CERTIFICATE OF APPROPRIATENESS

Property: 518 W 13th Street, E 69.2 ft of Lots 34, 35, & 36, Block 182, of Houston Heights Subdivision. The property includes a historic 1,592 square foot one-story bungalow single-family residence situated on a 6,920 square foot interior lot.

Proposal: Alteration/Revision—Applicant proposes to add a rear two-story 1,110 square foot addition.

Existing Left Elevation

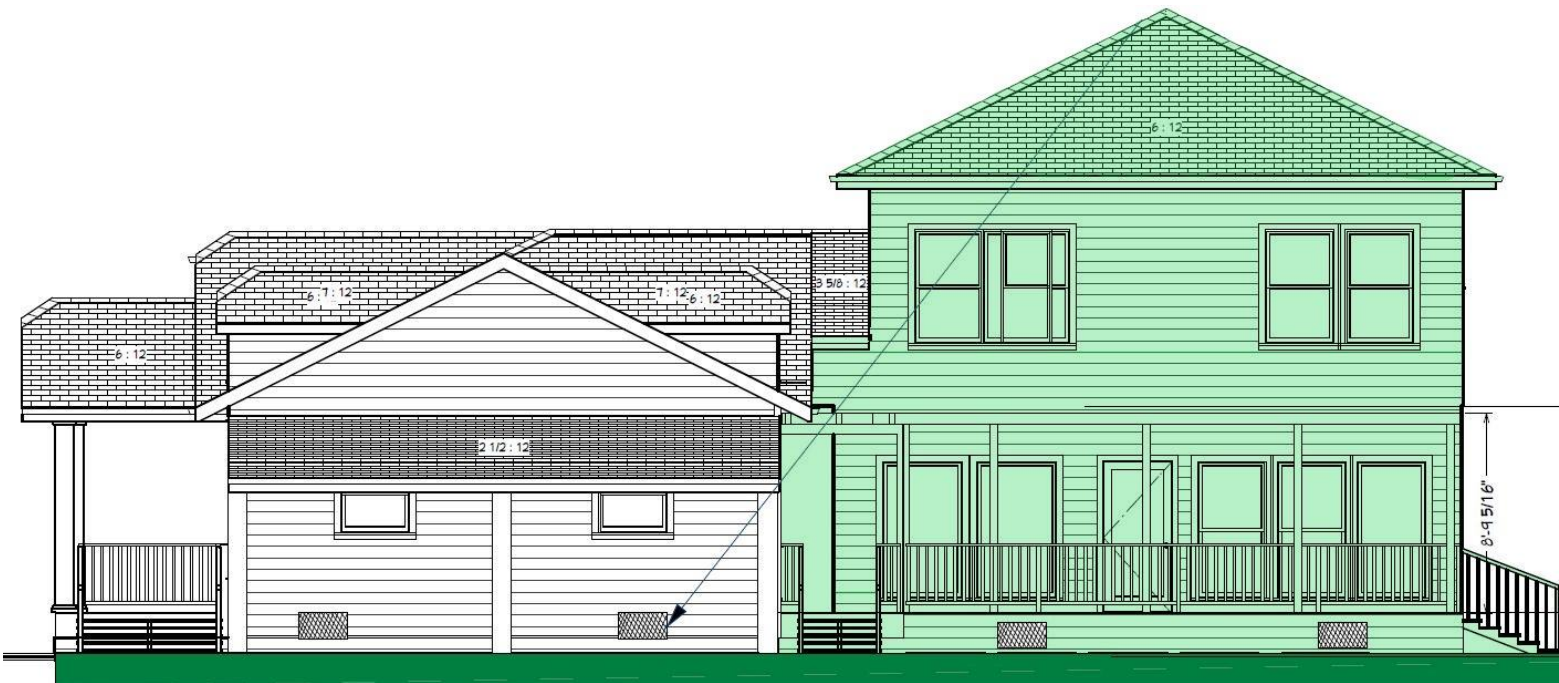
Proposal has a 2' by 6' inset at 40ft on the left elevation.
